Our Ref: Q144007
Our Contact: Mr Dominic Hammersley
Council Ref: 8/13/1481(3693529)

**RESPONSE TO FURTHER ISSUES - RECONFIGURING A LOT
(1 INTO 72 LOTS AND PARK) VIXIES ROAD, WONGA BEACH**

Property Description: Lot 32 on SP126925

Council Reference: 8/13/1481

LAYOUT PLAN - SHEET 2 OF 3
SCALE 1:1000

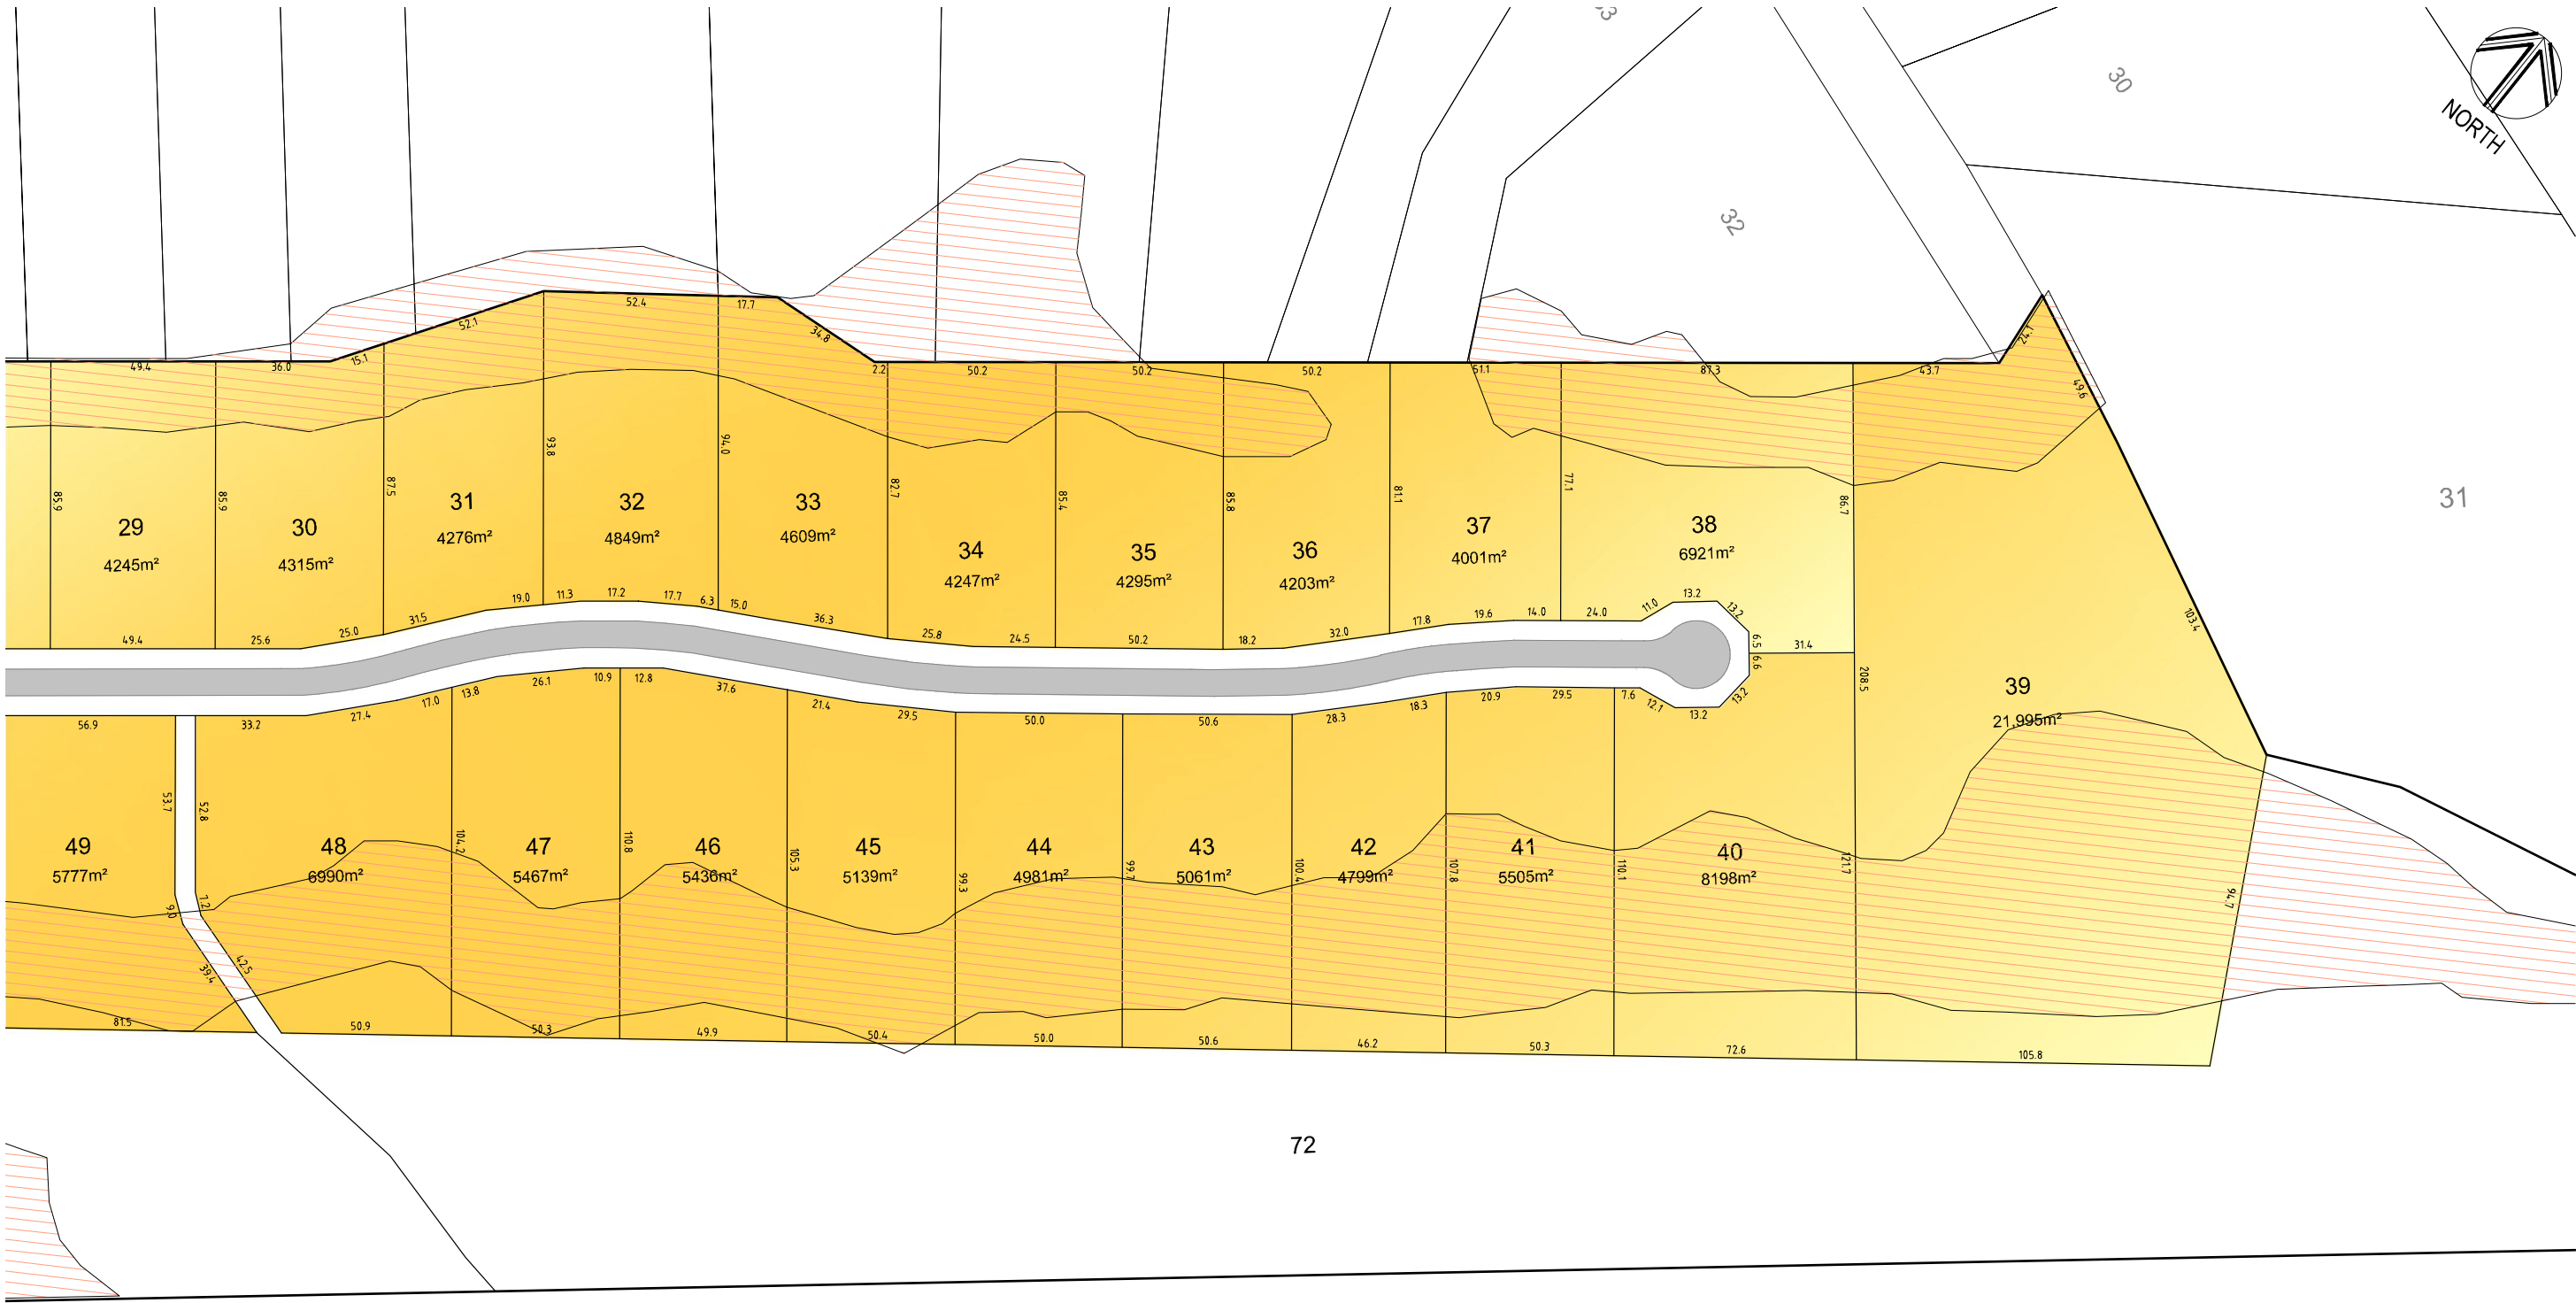
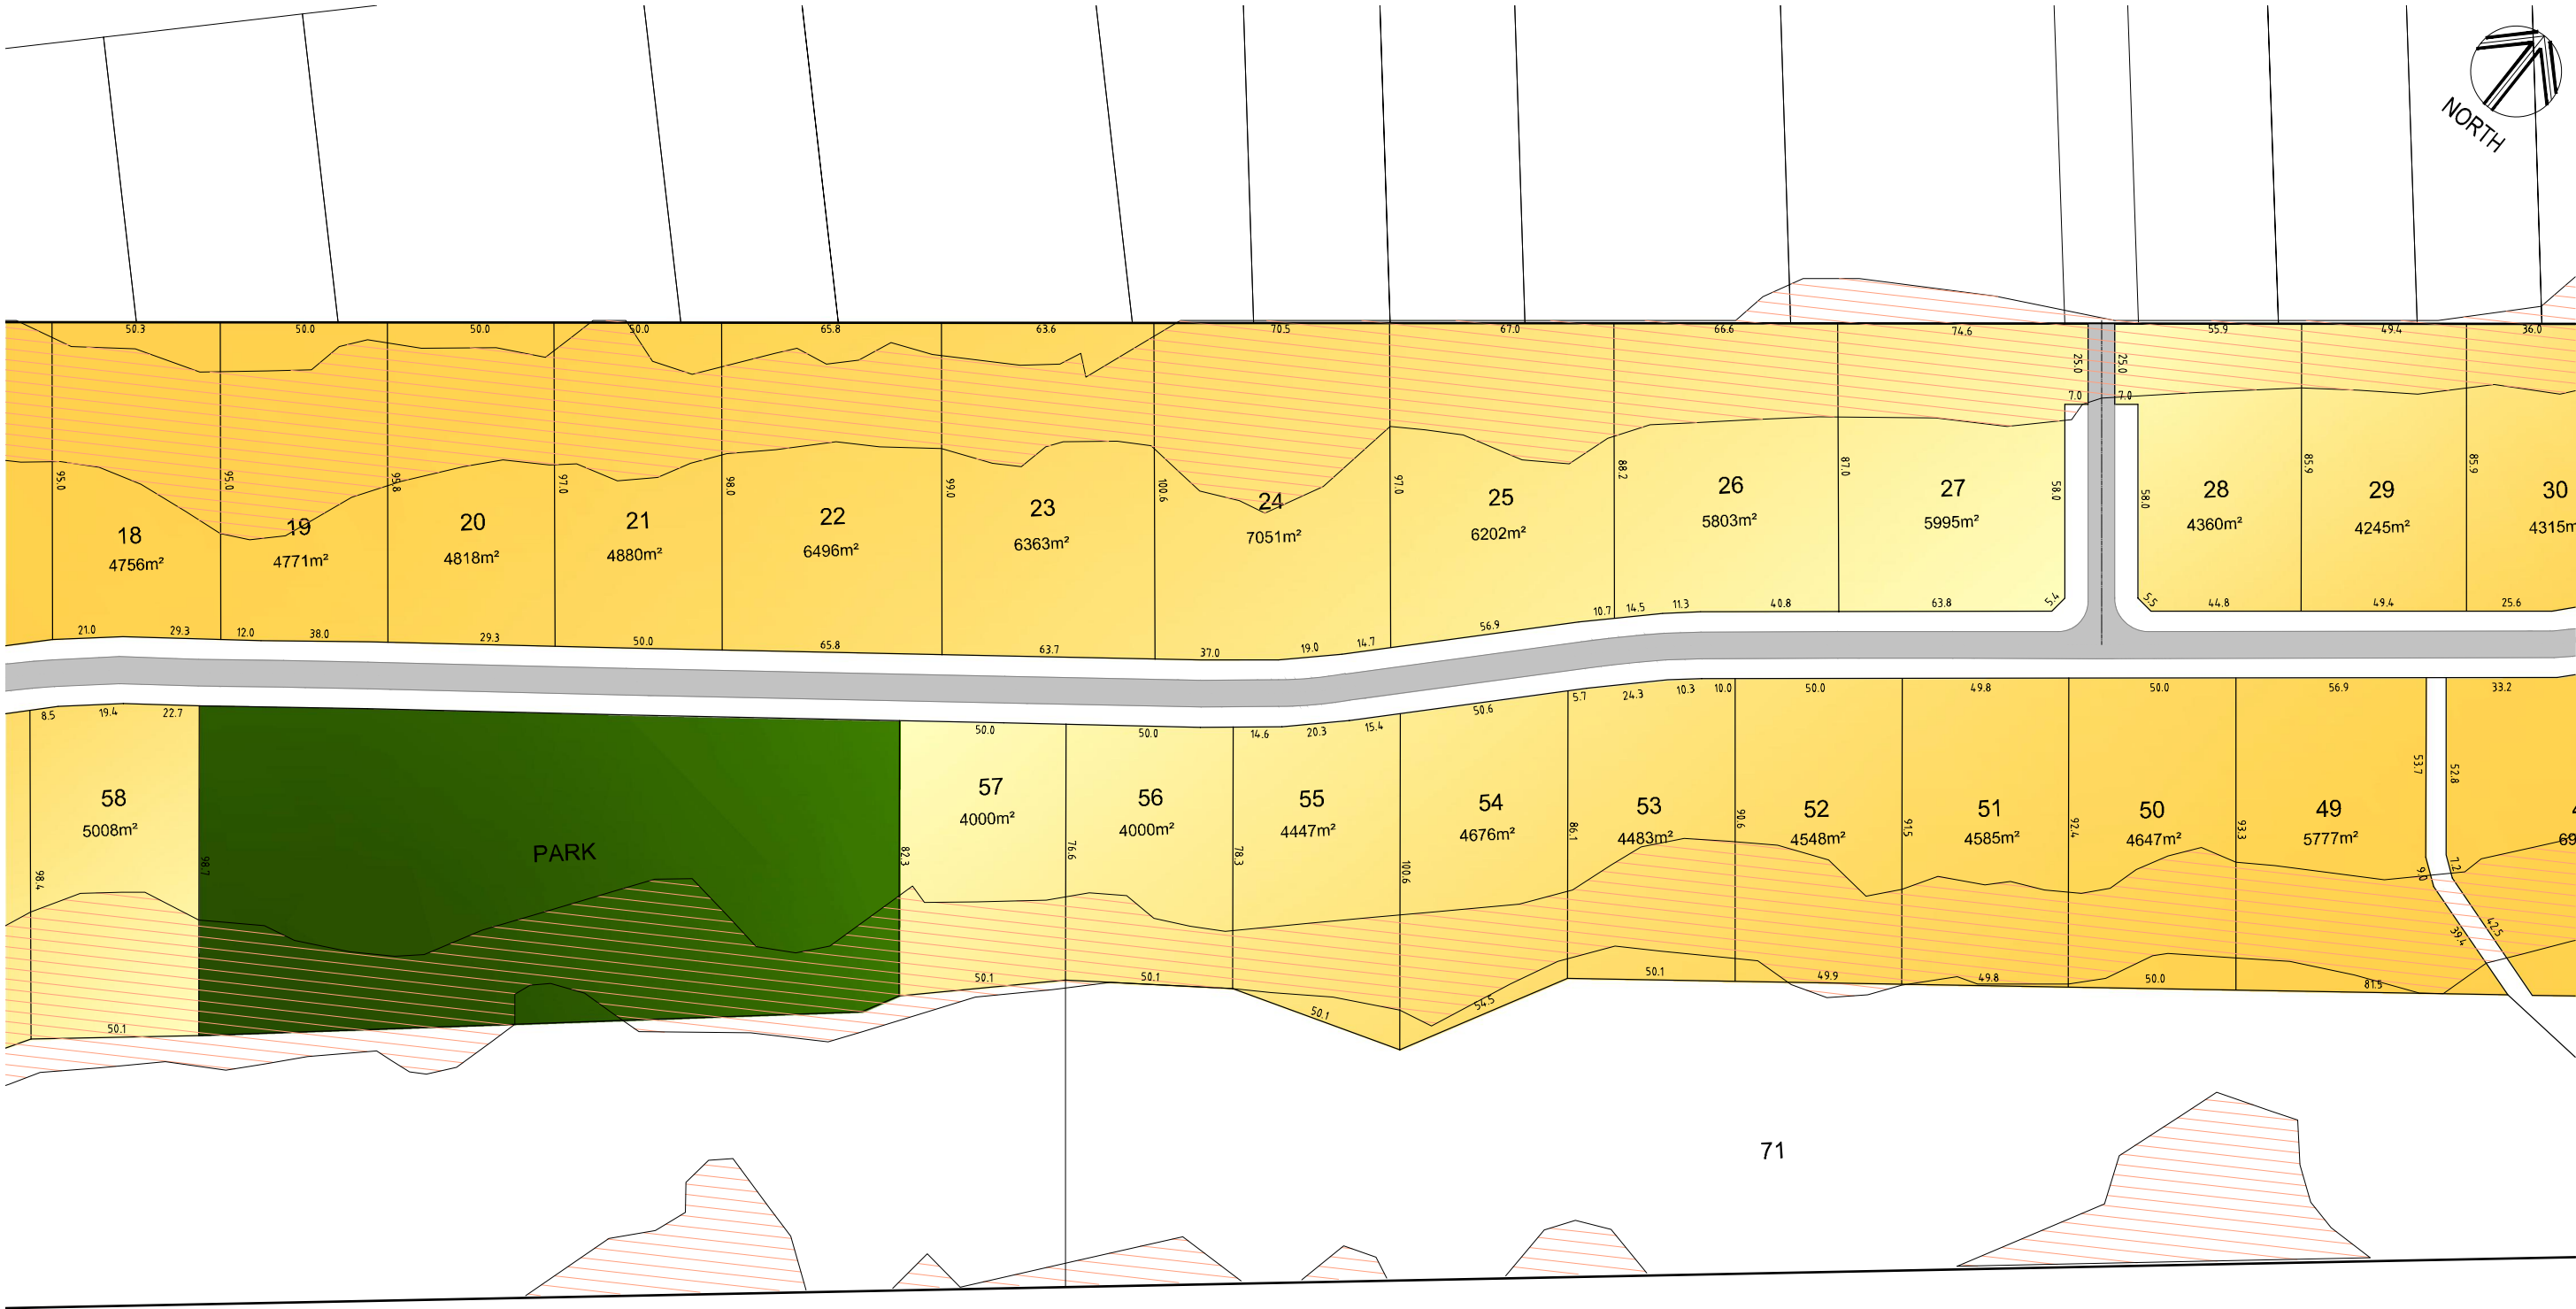
- d., the development concept has been subject to minor refinement in consideration of the current flood extent (refer **Attachment B – Revised Reconfiguring a Lot Plans**); however, the flood inundation risk is not such that the development concept required substantial change.

- > In response to 'Planning' Outstanding Information request item D:
 - o 1., Refer **Attachment A – Revised Reconfiguring a Lot Plans** that includes the dimensions and size of each proposed lot.
 - o 2., We identify a park lot between Lot 57 and 58. The use of this lot was previously unidentified.

- > Re-configuration of the proposed lots to incorporate drainage channels.
- > Refinements to lot boundaries to improve responsiveness to overland flows associated with a 100 year ARI.
- > A shortening of the road leading to the cul-de-sac resulting in the termination of the cul-de-sac at proposed lots 38 and 40.
- > A change of access to proposed lot 39 (now accessed off the road to the north).
- > A change of Applicant details per amended IDAS Form 1.
